ADDENDUM NO. 2

Reference: Training Housing – Division of Services for the Blind and Visually Impaired
Utah State Office of Rehabilitation – Salt Lake City, Utah
DFCM Project No. 09240200

STAGE TWO
ADDENDUM NO. 2

Utah State Office of Rehabilitation
Services for the Blind and Visually Impaired
Training Housing
1991 & 1995 W 400 North
Salt Lake City, Utah 84116

2 TYPICAL WALL SECTION
3/4"=1'-0"

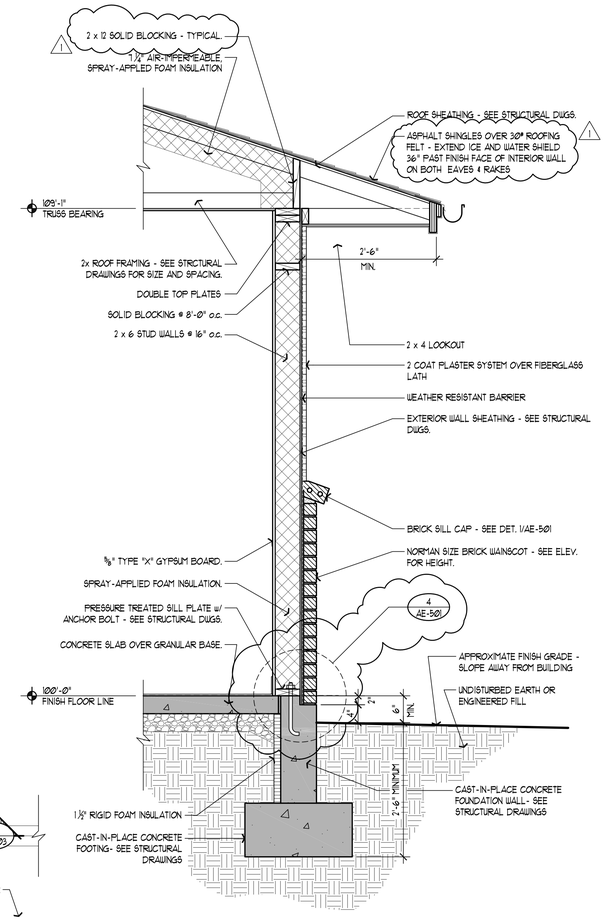
1. Added "w/ capped ends" to Sheet Notes 31 & 32.
2. Replaced Sheet Note 33 with the following: "Steel column cap (typical)."
3. Added Sheet Note 34: "8 x 8 steel column – see structural dwgs."
4. Typical Wall Section 2 – Revised note for roofing system.
5. Typical Wall Section 2 – Added detail reference for detail 4/AE-501.
6. Typical Wall Section 2 – Heel height called out with blocking size.
7. Trellis Plan 3, Trellis Section 5 & Trellis Elevation 6 – Added detail reference 8/AE-503 and Sheet Note 34.
8. Trellis Elevation 6 – Revised dimensions at masonry pilaster.

Item 04-13: Bidding Question #13 – "QUESTION: Do all the exterior walls need to have wall flashing behind the brick and return over the foundation's? Details 4 & 9 on AE-501 call for metal flashing. Detail 2/AE303 doesn't show flashing?" **Answer: Yes, provide all exterior walls with the flashing detail. Detail 2/AE-303 has been revised to provide a reference to detail 4/AE-501.**

8 BASE DETAIL
1" = 1'-0"

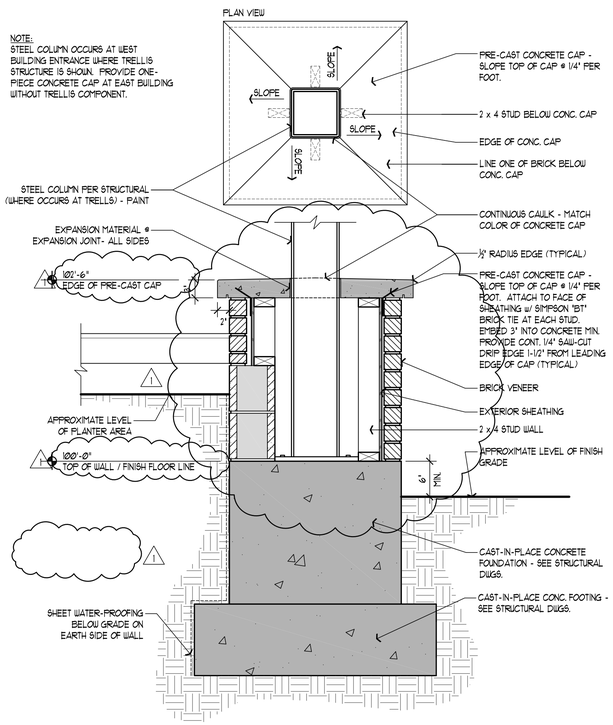
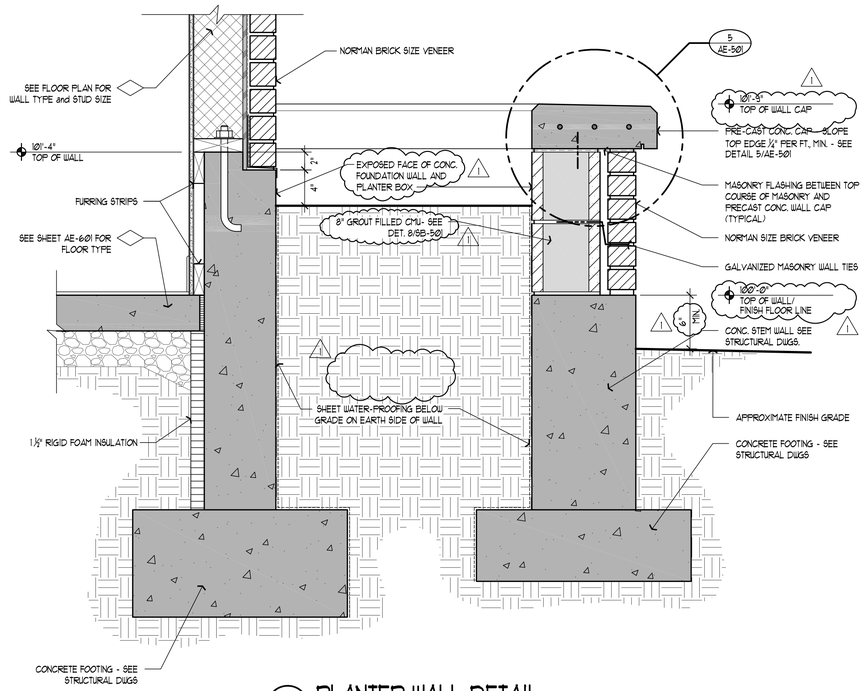
1. Detail 7 – Heel height called out with blocking size.
2. Detail 8 – Height of pre-cast cap and top of foundation height called out; Deleted filter fabric around free draining granular material.

3. Detail 9 – Height of pre-cast cap and top of foundation height called out; Deleted filter fabric around free draining granular material; Delete requirement of plastered foundation; Add dimension from finish grade to top of foundation.
4. Add detail 10, 11 & 12.

Item 04-14: Bidding Question #14 – "QUESTION: Should we include a cost to plaster the exposed foundation walls? There was a note about plastering the exposed foundation of the planters." **Answer: No. This note has been deleted from the planter detail 9/AE-501.**

AE-602

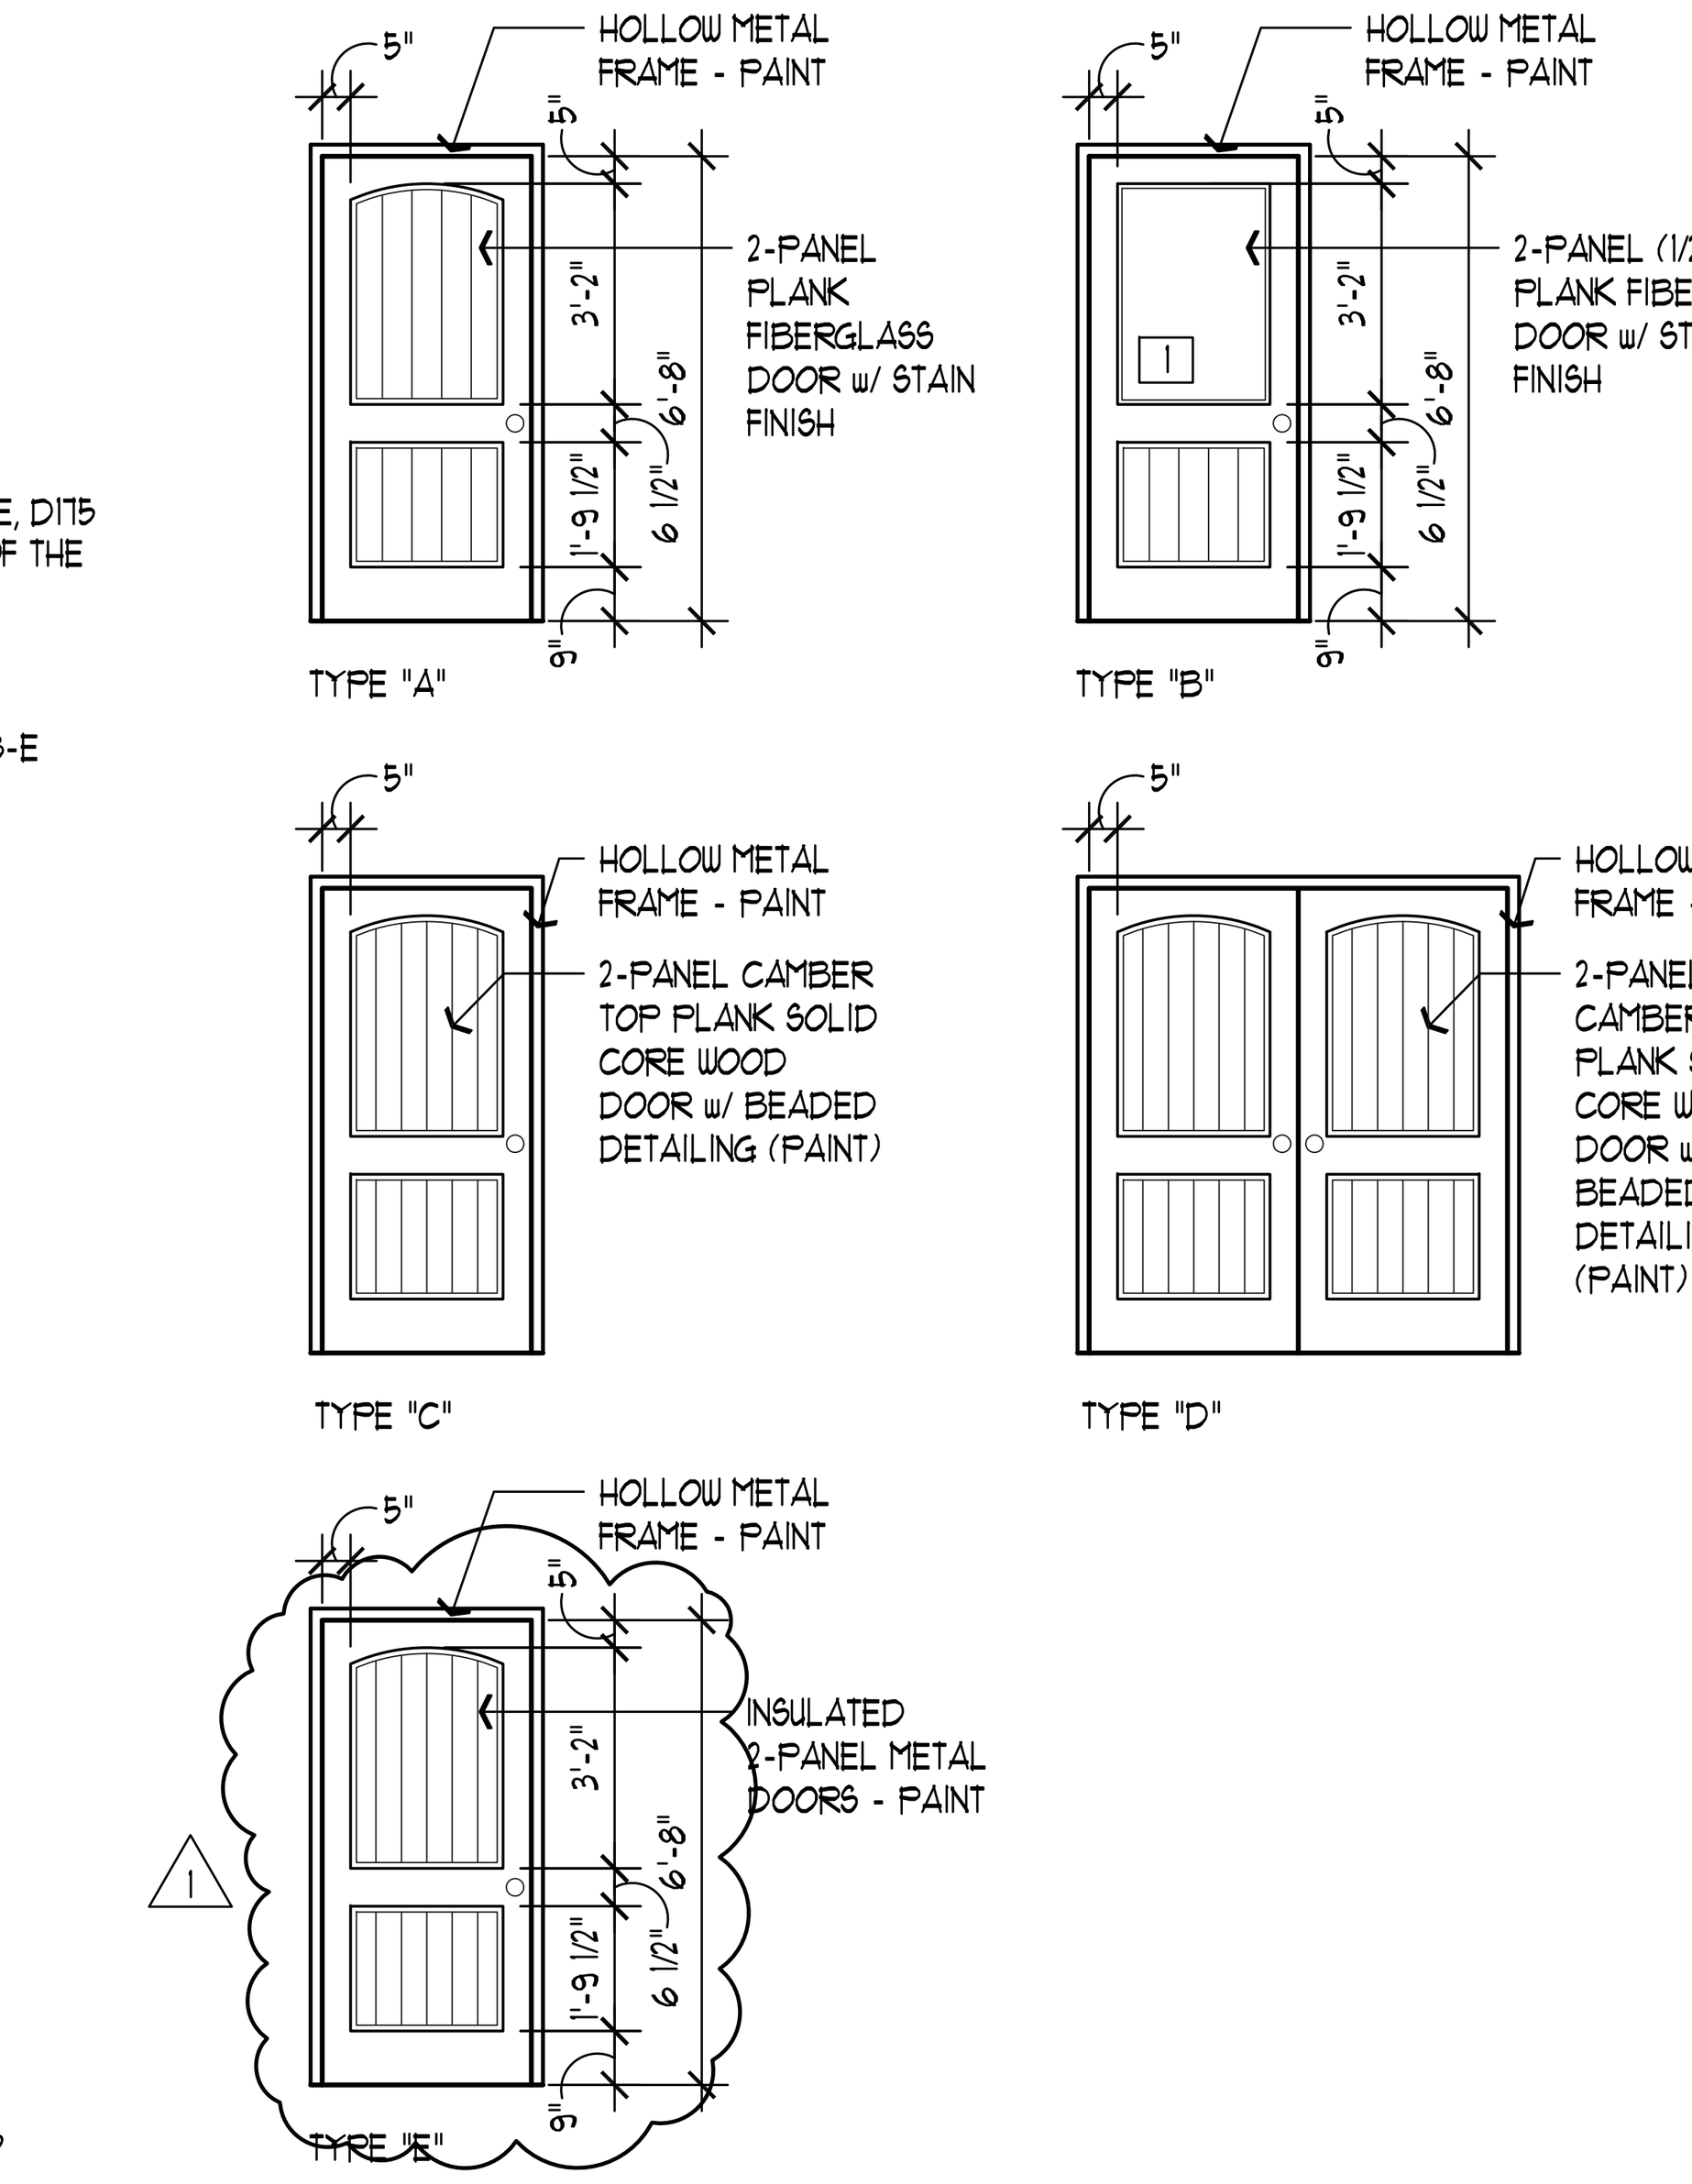
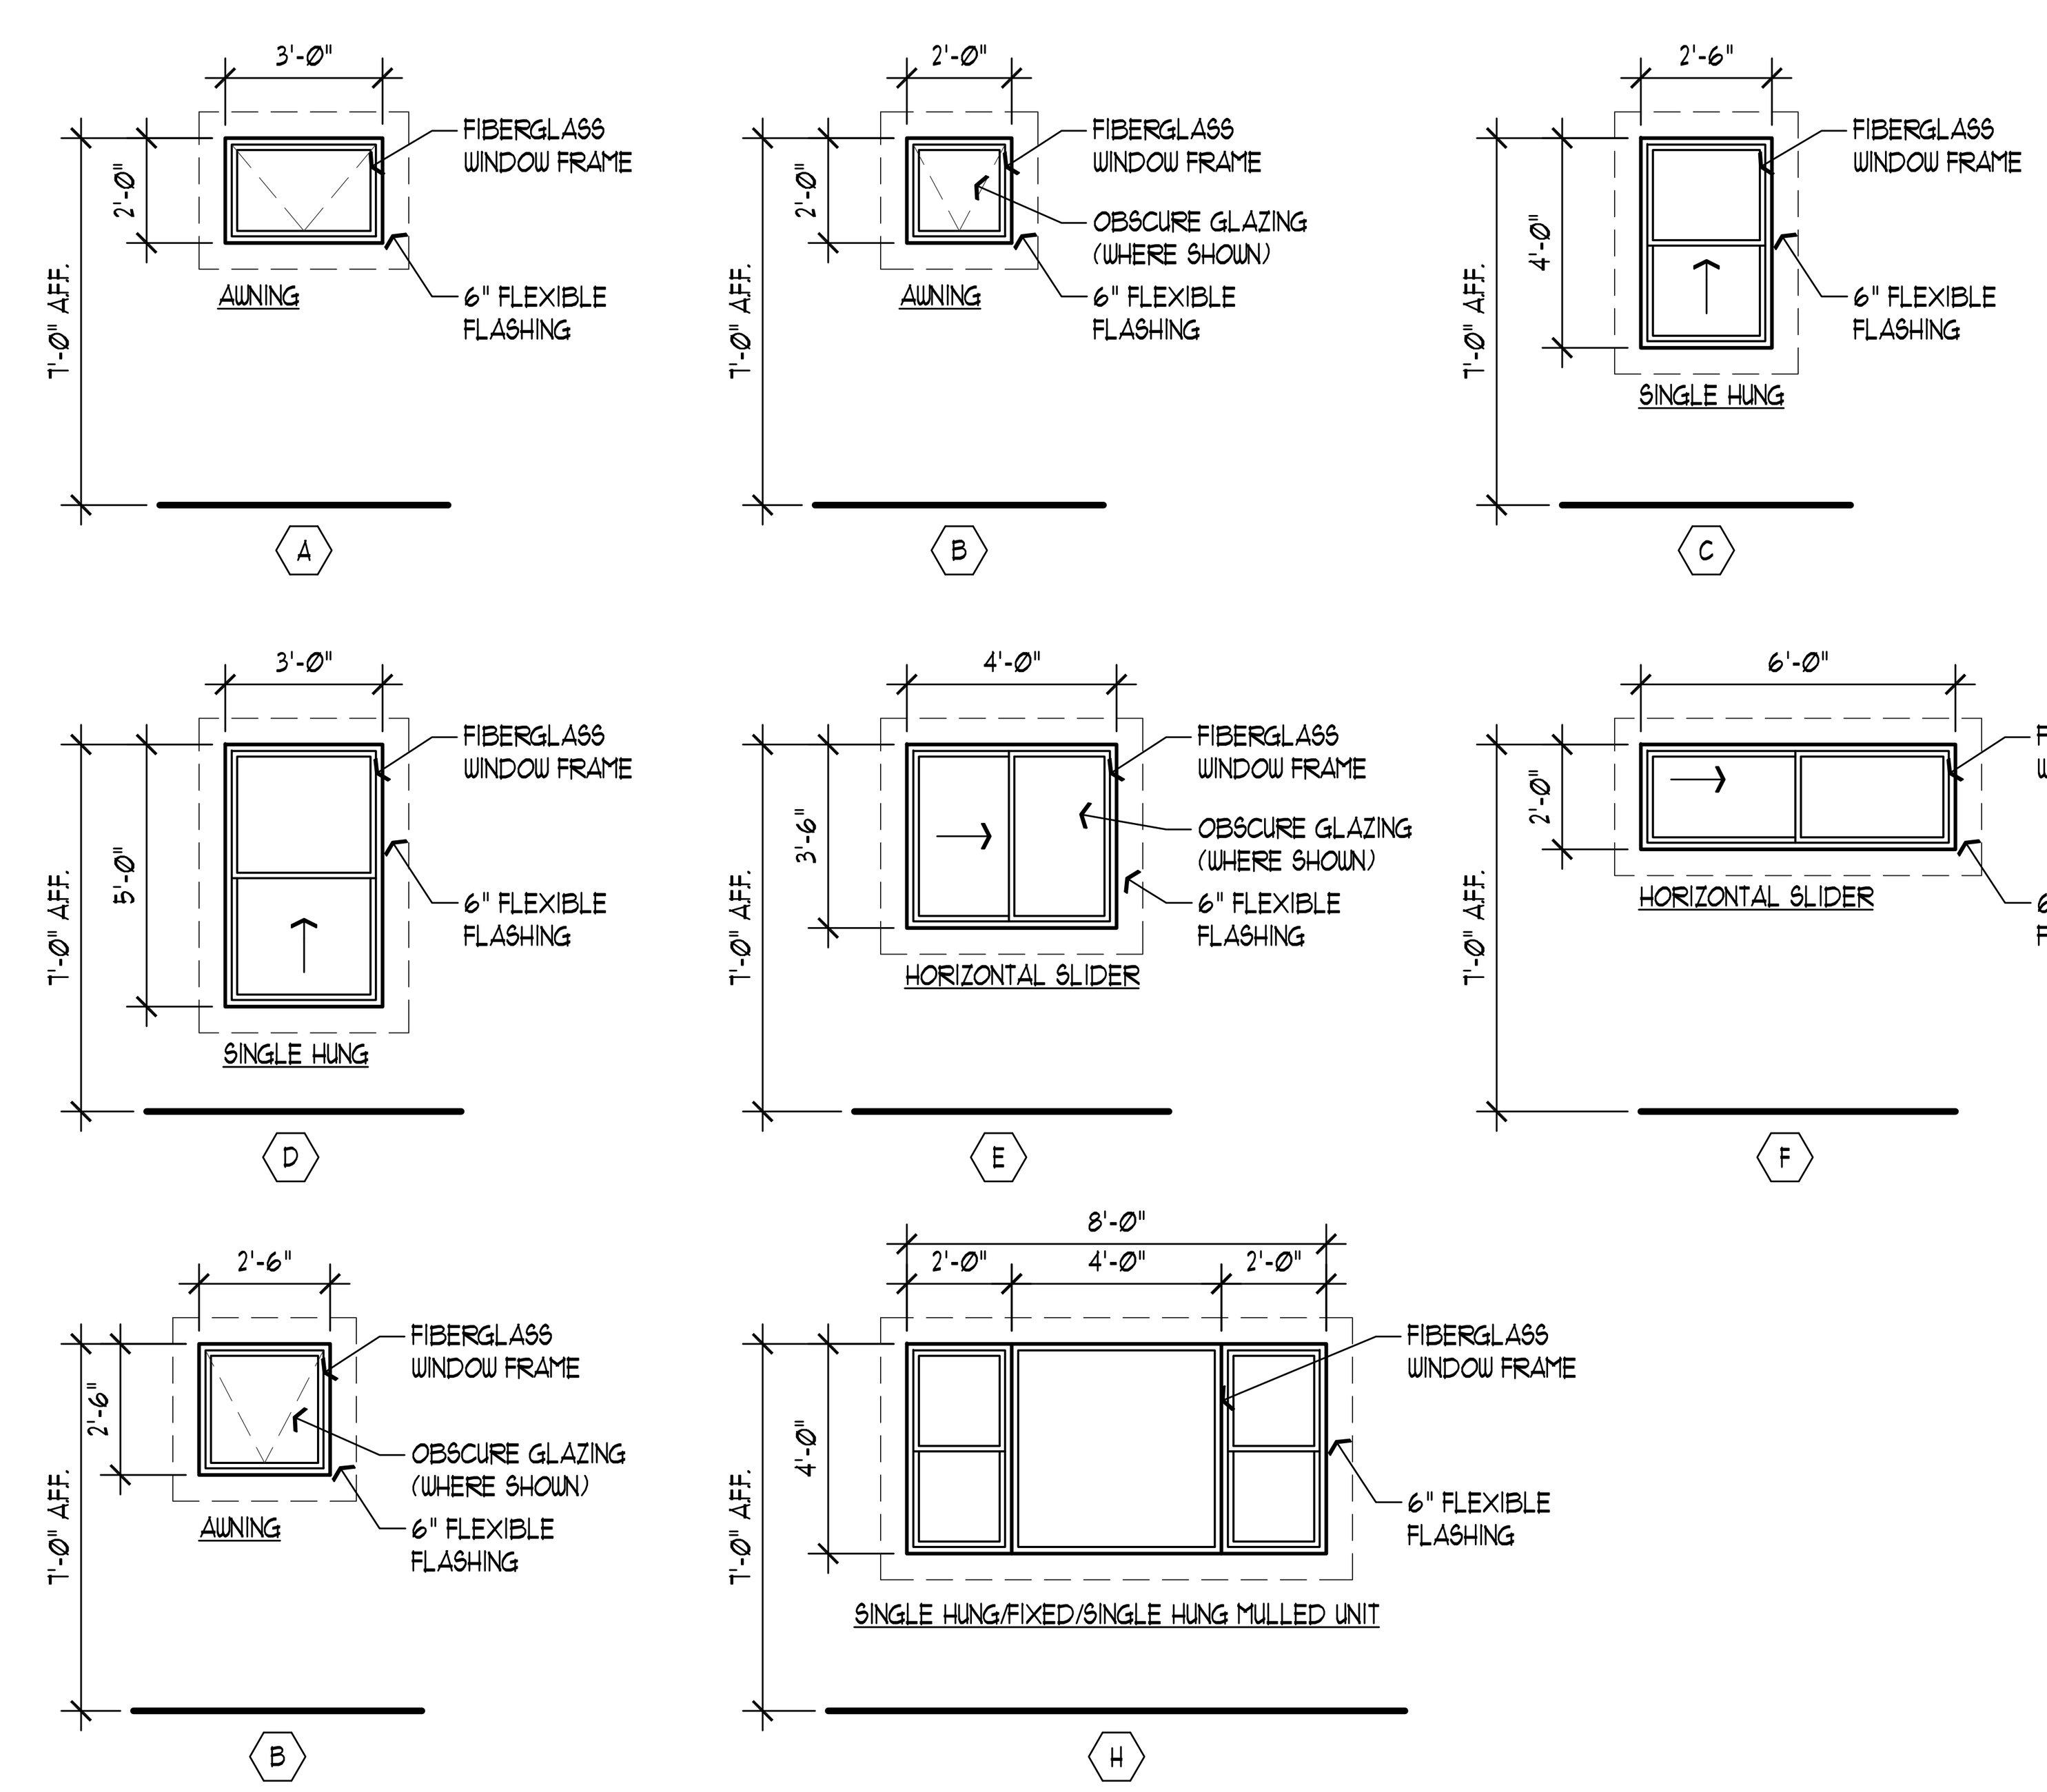
1. Revise style of Door Type E.
2. Glazing Schedule deleted & replaced with Glazing Notes.
3. 128 Common Area - Change E/N wall finish designation to "PTWD1-A."
4. 129 Common Area – Change W/S wall finish designation to "PTWD1-A."
5. 153 Fire Riser – Change ceiling finish to "PTDC1" and add the following note in the remarks section "match wall color."
6. Detail 2 – revise size of trim to "3/4"cont. maple window trim (stain) and add "1/2" reveal – see det. 24/AE-503."

POWER PLAN

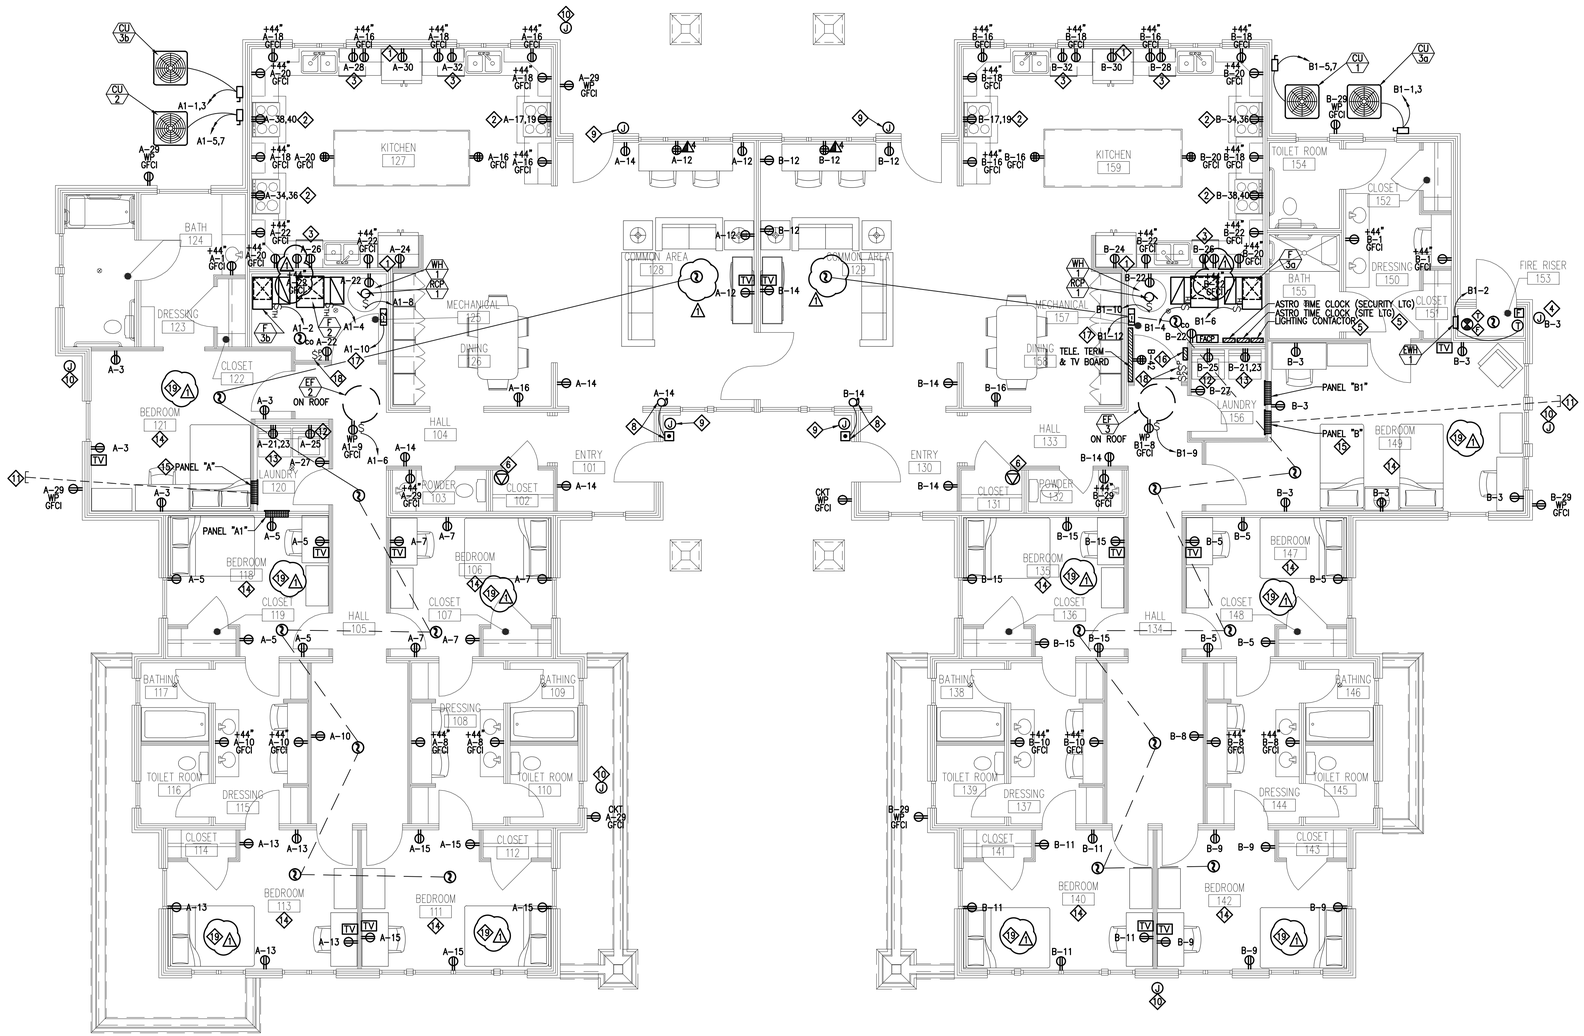
1. Provide Smoke Detector in Common Area 128 and 129 in both buildings (total of 4).
2. Provide duplex GFCI receptacle (Kitchens 127 and 159 at +44" at countertop area above dishwasher bordering Mechanical rooms. (total of 4)
3. Clarification item: All outlets in all Bedrooms to be circuited to AFCI breaker as shown on Panel Schedules "A"& "B" Sheet EU-501.
